24Groundwater Transfer Review Summary Form

Transfer/PA # T- 14652

Application: T-14652

Applicant Name: Nesika Beach-Ophir Water District

ROGUE R > PACIFIC OCEAN - AT MOUTH
 ROGUE BASIN

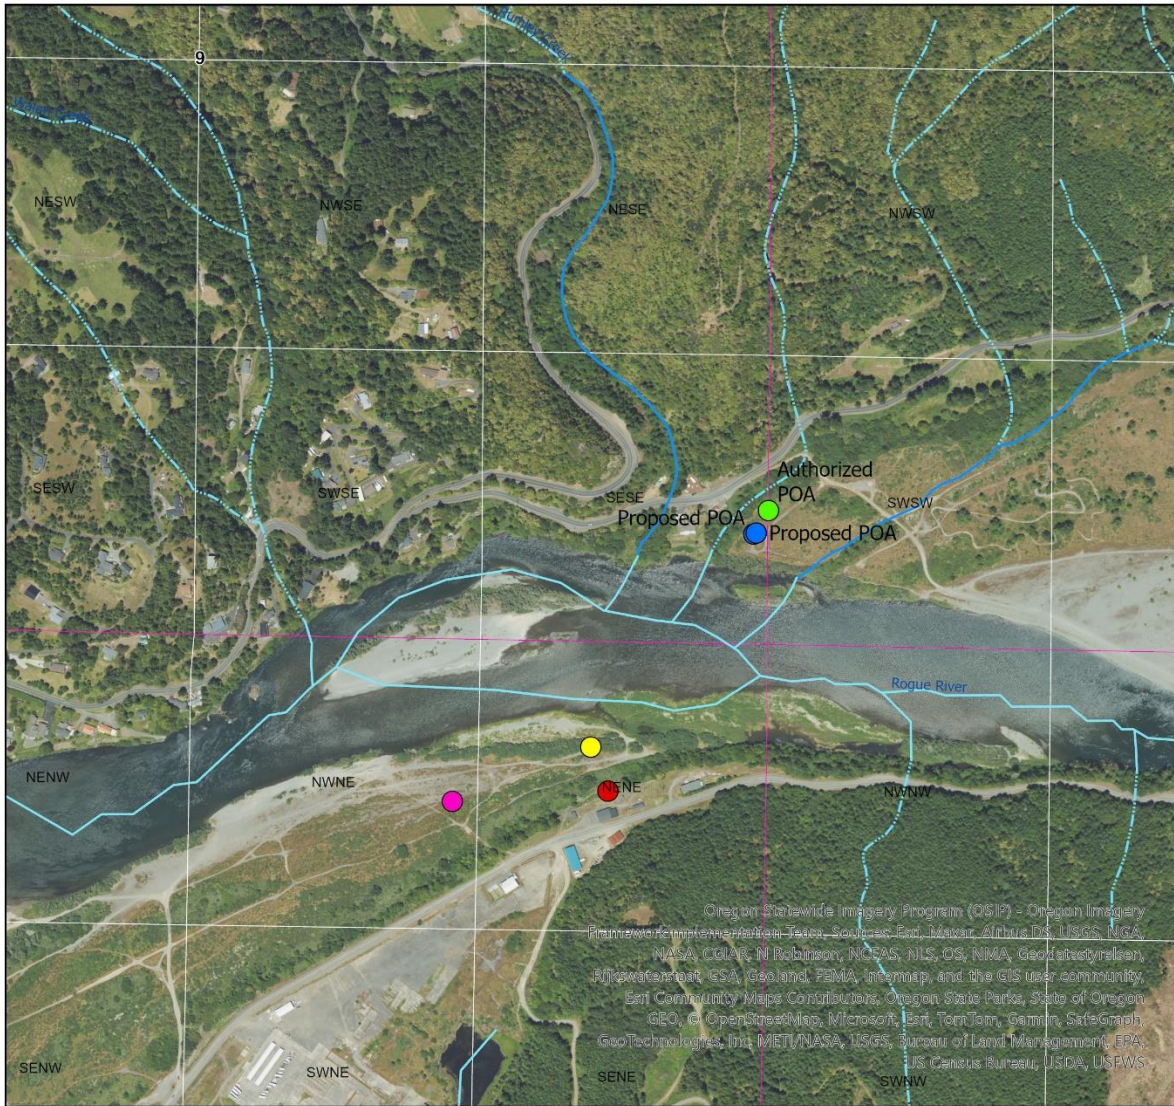
- Water is not available (80% exceedance level) in the Rogue > Pacific Ocean-At Mouth reach during July, August, September, and November.
- Rumley Creek: Proposed POAs are moving closer to Rumley Creek but further away from closest upstream POD with no remaining PODs to confluence with Rogue River.
